35/36-01A 5806 Warwick Place R
(Somerset Historic District)

FAX TRANSMITTAL SHEET

12 September 2001

RE: Hughes/Stern Residence
5806 Warwick Place
Permit No. 238984

Sketch: Currently Proposed Street Facade
Date: 12 September 2001

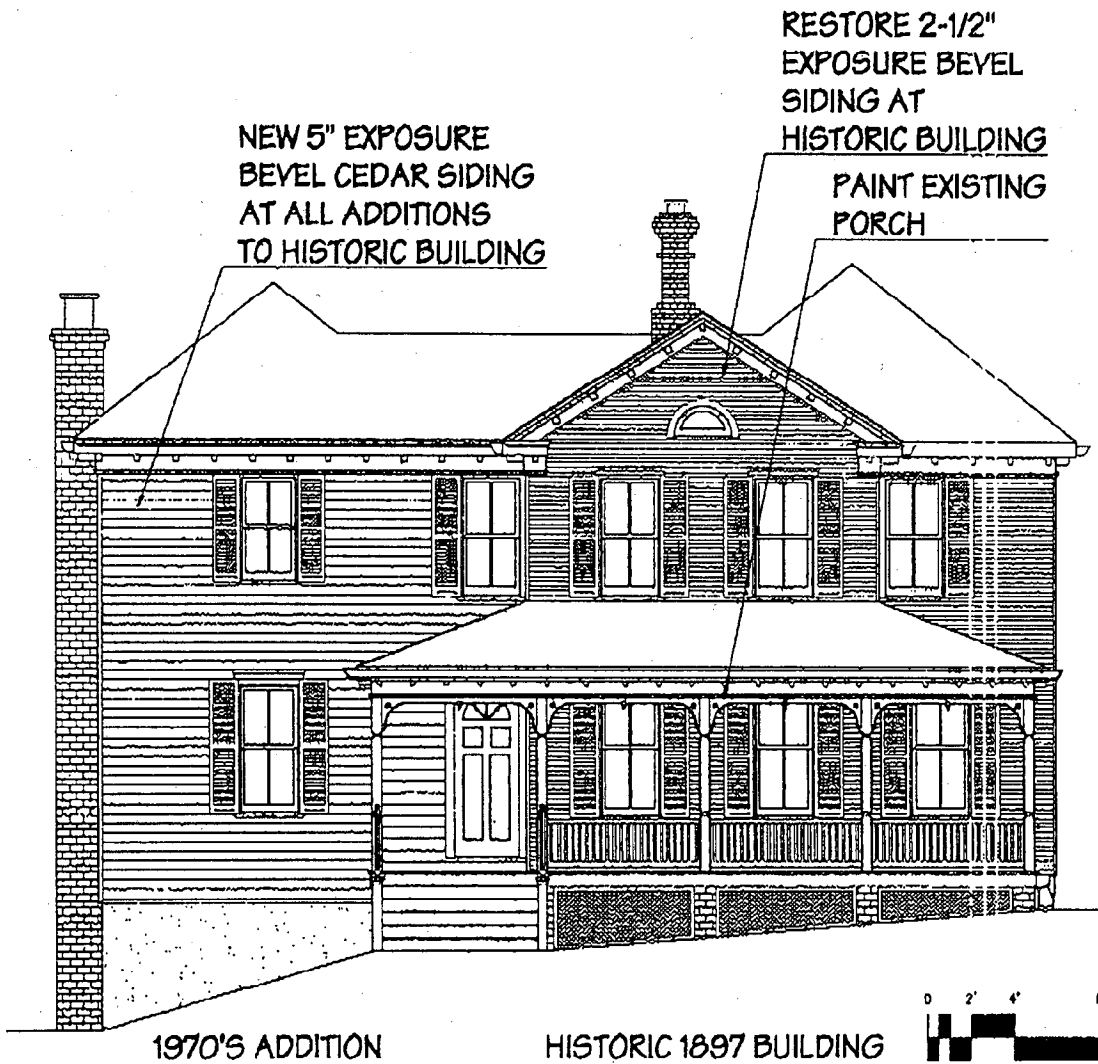
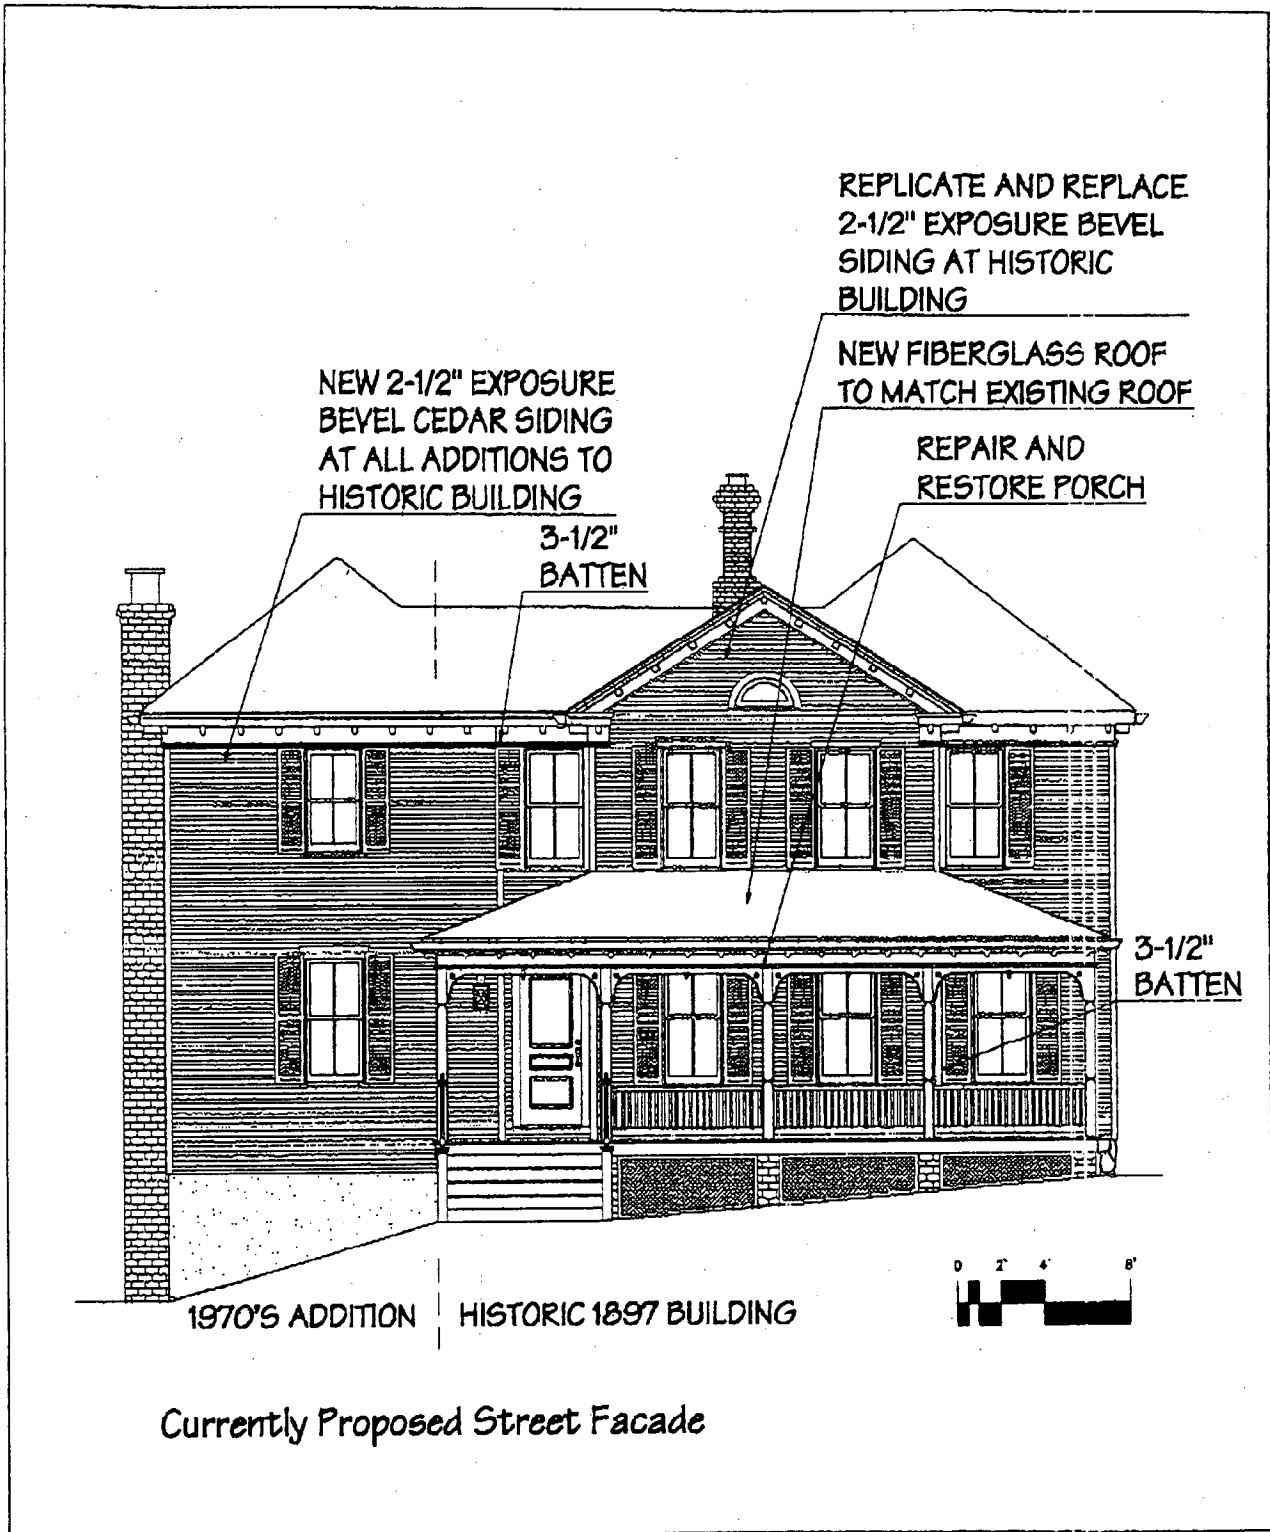
2. Installation of siding on the new addition to match the existing narrow exposure siding profiles.
The second issue relates to the new siding to be used on the former addition and the new addition that we have designed. We originally proposed to double the exposure on the new portion to contrast it with the original house. As you can see from the attached sketches, our original proposal did not clearly define the line between the old and new. The original house extended to the line of the porch columns. After seeing the house with the original siding, we began to reconsider our decision to contrast the exposure and would like to seek approval for installing a similar exposure siding on the new additions with a vertical batten to delineate the historic building from the newer additions on the street façade only. The only other intersection between old and new, along the right side, is clearly delineated by a setback of the new building and by a contrasting stucco foundation wall. A sketch of the originally proposed front façade is attached, along with a sketch of the currently proposed solution.

The other houses of similar period on Warwick Street all have narrow exposure siding for both the new and the original siding, and we feel that this approach will be more sympathetic with the street, while more accurately delineating the edge of the original house. Unlike some of its neighbors, 5806 Warwick Place will have a very clear demarcation between new and old. The use of vertical battens where the new and old portions meet, by the change in the foundation from stone to stucco, and the clear offset in plane along the North side all provide a clear line between old and new.

We propose to use the same narrow exposure lap siding of the identical profile as the original for all new work and use the change of plane and vertical batten at the intersection of the new and the original portions of the house. We believe this is more consistent with the other houses on the block and more aesthetically pleasing, while preserving the distinction between old and new.

*9/17/01 -
Staff approves
all this work -
While encouraging
presentation of siding
at 1st floor level under
porch, but not requiring it.
PZ*

Sketch: Currently Proposed Street Facade
Date: 17 August 2001

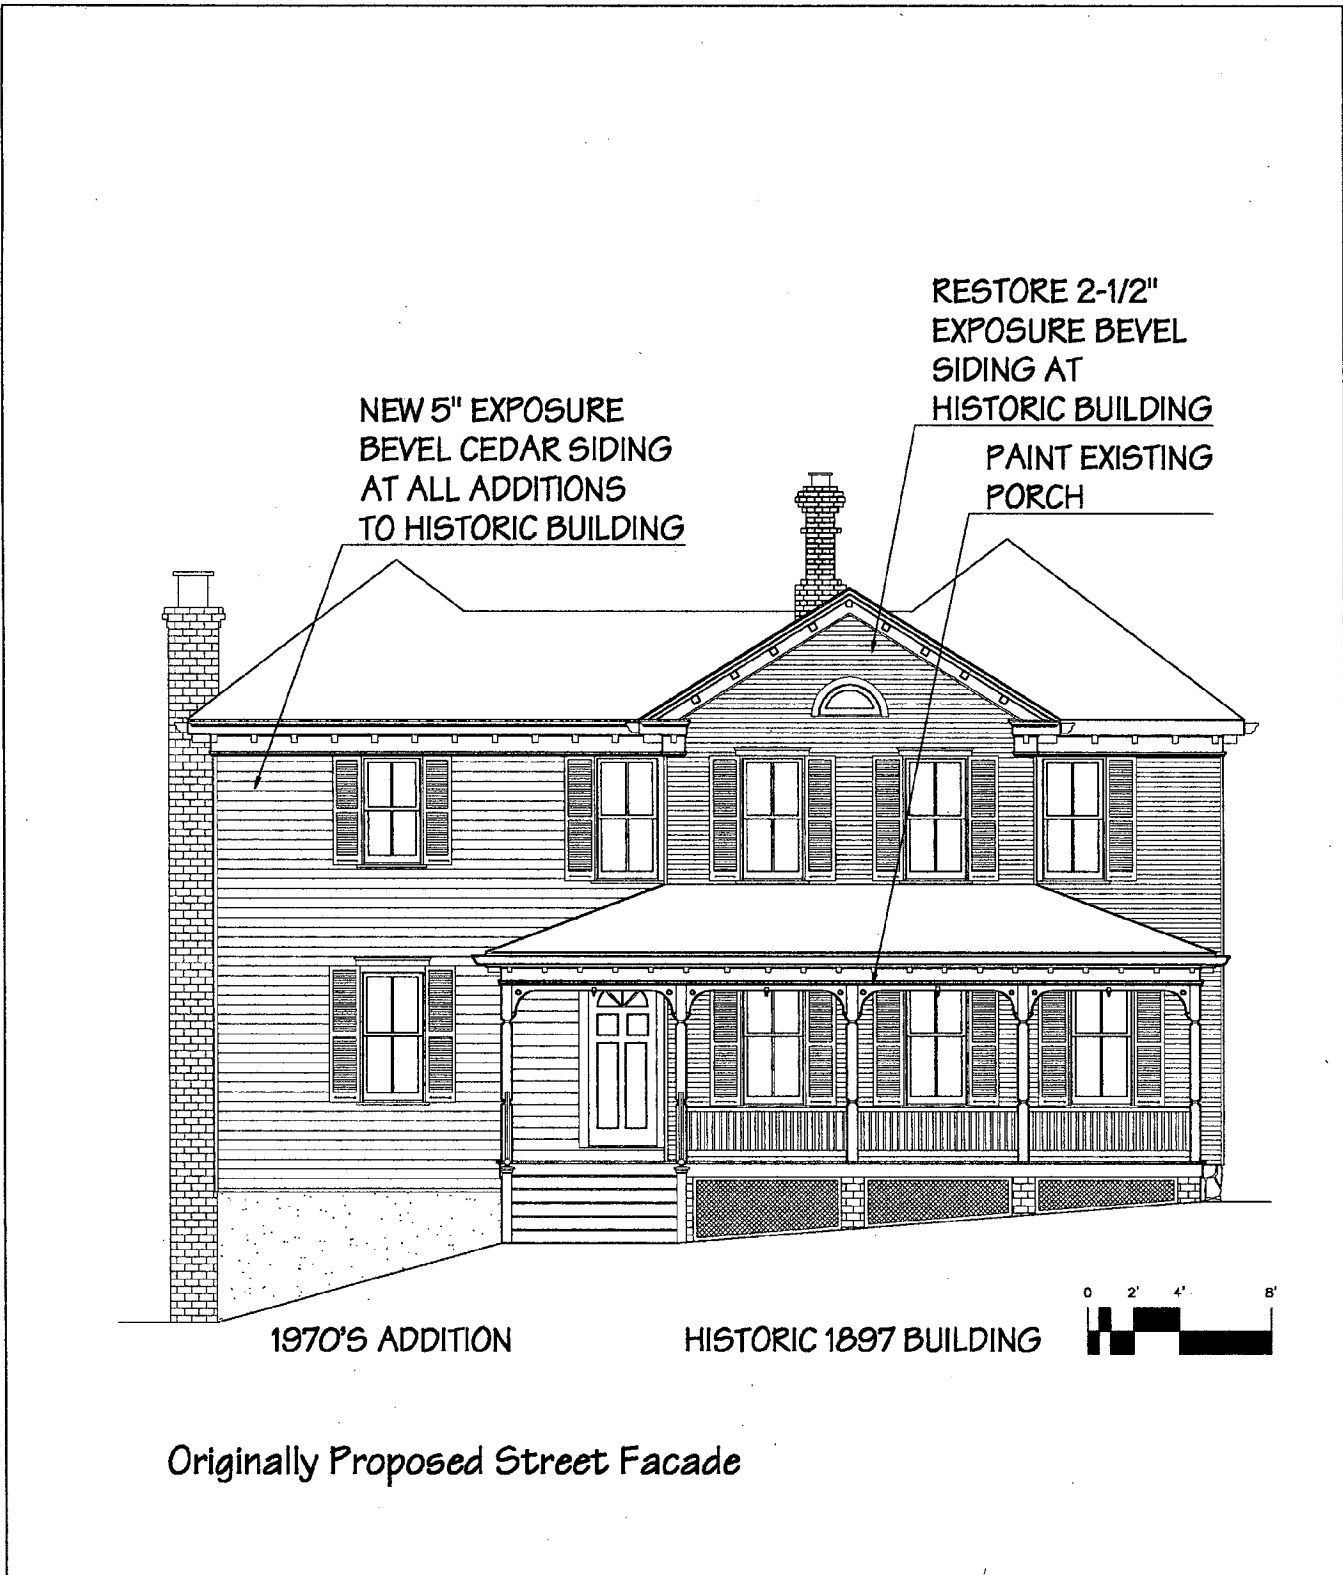
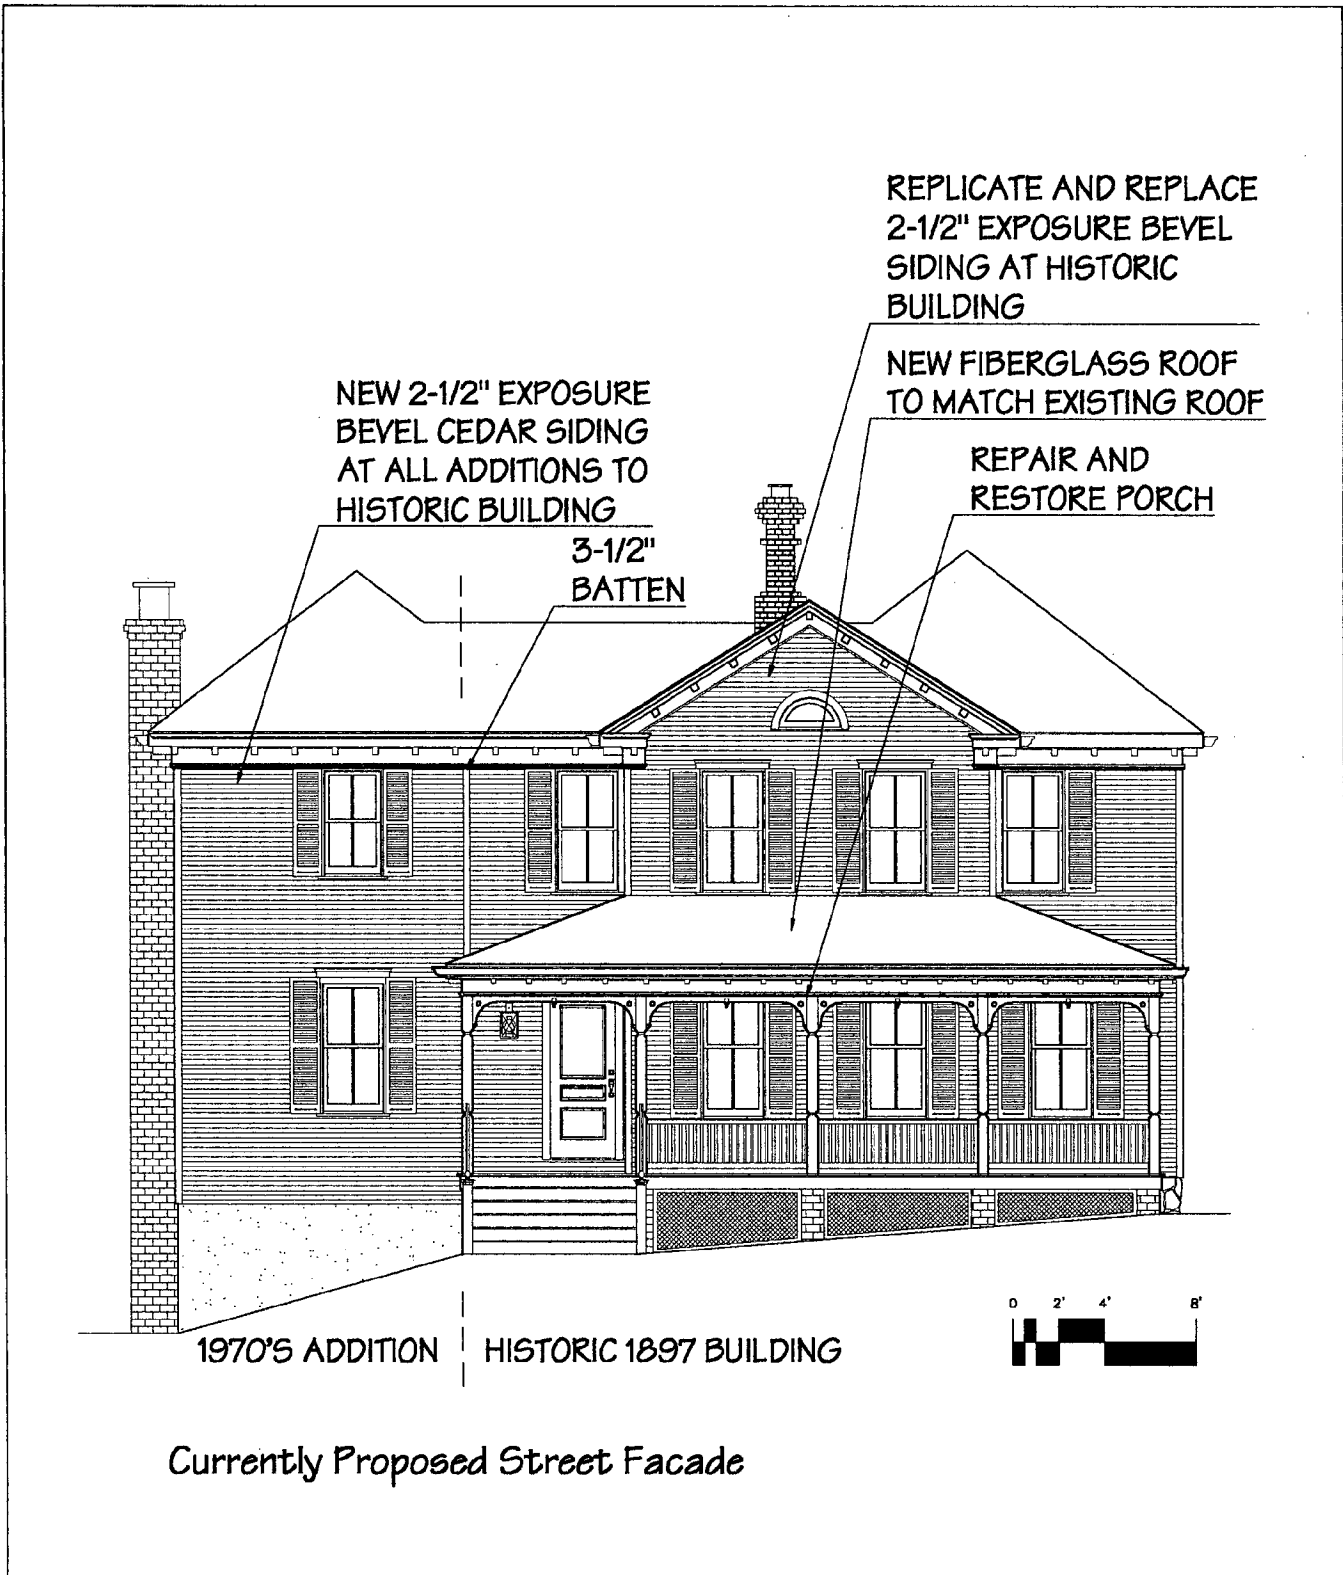
The second issue relates to the new siding to be used on the former addition and the new addition that we have designed. We originally proposed to double the exposure on the new portion to contrast it with the original house. As you can see from the attached sketches, our original proposal did not clearly define the line between the old and new. The original house extended to the line of the porch columns. After seeing the house with the original siding, we began to reconsider our decision to contrast the exposure and would like to seek approval for installing a similar exposure siding on the new additions with a vertical batten to delineate the historic building from the newer additions on the street façade only. The only other intersection between old and new, along the right side, is clearly delineated by a setback of the new building and by a contrasting stucco foundation wall. A sketch of the originally proposed front façade is attached, along with a sketch of the currently proposed solution.

I recall that you had suggested the use of a batten as a means of delineating the end of the original house. The other houses of similar period on Warwick Street all have narrow exposure siding for
5272 River Road Kenwood Building Suite 610 Bethesda Maryland 20816 301.652.4022 FAX 301.652.4094

both the new and the original siding, and we feel that this approach will be more sympathetic with the street, while more accurately delineating the edge of the original house.

Enclosure: Proposed East Elevation, dated 17 August 2001, showing vertical batten locations.

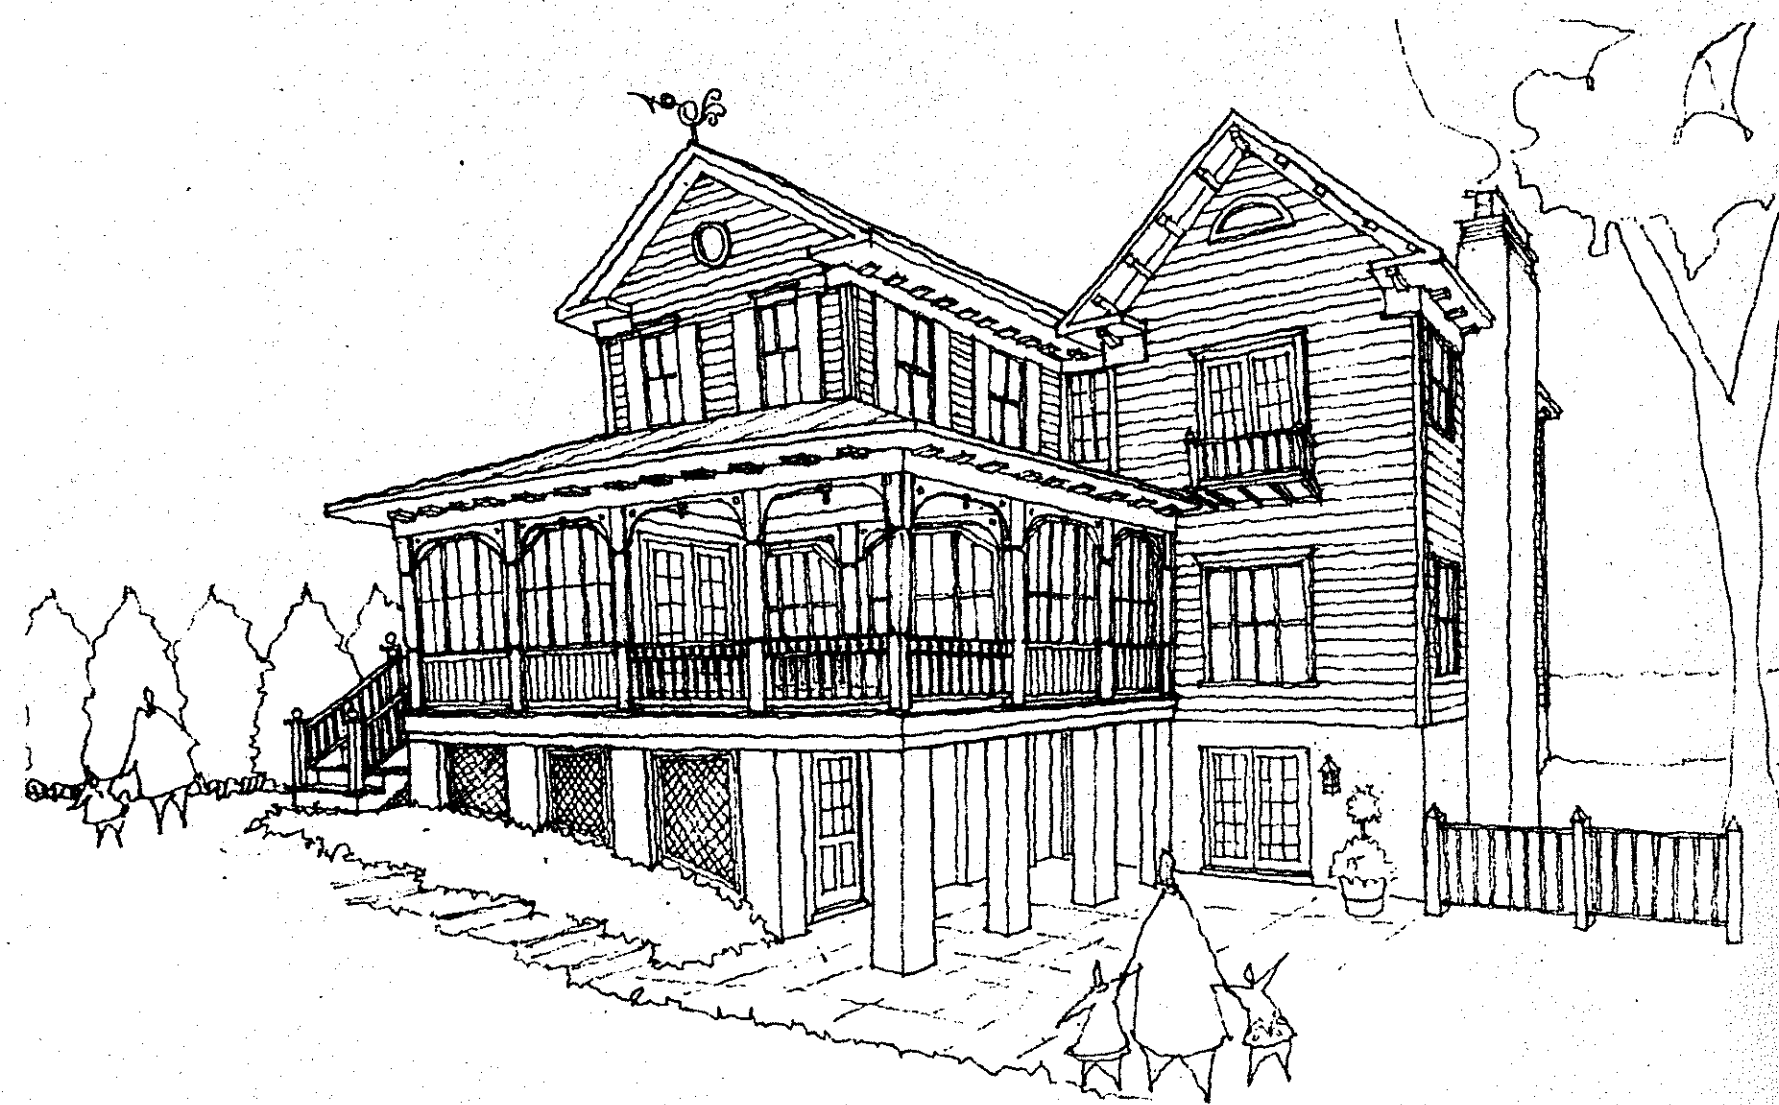
We propose to use the same narrow exposure lap siding of the identical profile as the original for all new work and use the change of plane and vertical batten at the intersection of the new and the original portions of the house. We believe this is more consistent with the other houses on the block and more aesthetically pleasing, while preserving the distinction between old and new.

The Montgomery County Historic Preservation Commission approved our request. Please fabricate siding in a profile identical to the original historic siding for use for all new work and the replacement siding mentioned above. Please note the attached sketch that shows the introduction of a vertical batten in portions of the East façade that clearly demark the junction between the old and the new building.
